No.: SB-SC-106

# SERVICE BULLETIN

MODEL AFFECTED:	SportCruiser operating outside EASA rules	
SUBJECT:	Inspection of rivets on the firewall	
_	S/N C0692, S/N C0693, S/N C0694, S/N C0695, S/N C0696, S/N C0697 S/N C0698, S/N C0699, spare part from order No. DLV-2024-000086	
COMPLIANCE:	Within the next 100 flight hours / annual inspections, whichever occurs first.

This Service Bulletin contain instructions how to inspect and replace non-compliance rivets on the firewall.

Fig. 1: Firewall

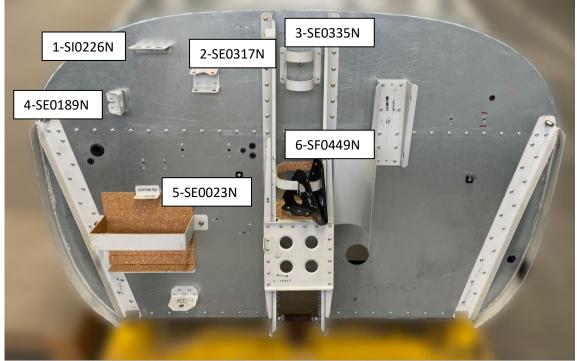
- NOTE: Do not disconnect the fuel hose.
  - 5) Unscrew the relay and remove flow meter on bracket SE0317N (2, Fig. 1).

- 6) Remove the tank at the SF0449N holder (6).
- 7) Inspect rivets on brackets and holders as Fig. 1 shows. Fig. 2 and Fig. 3 can be used as a guidance.

- 9) Remove equipment, hose and wires at the affected parts as needed.
- 10) Drill out non-compliance rivets and replace them with the correct rivets (001).
- 11) Restore the aircraft to airworthy condition.
- 12) Update aircraft records to reflect compliance with this Service Bulletin.
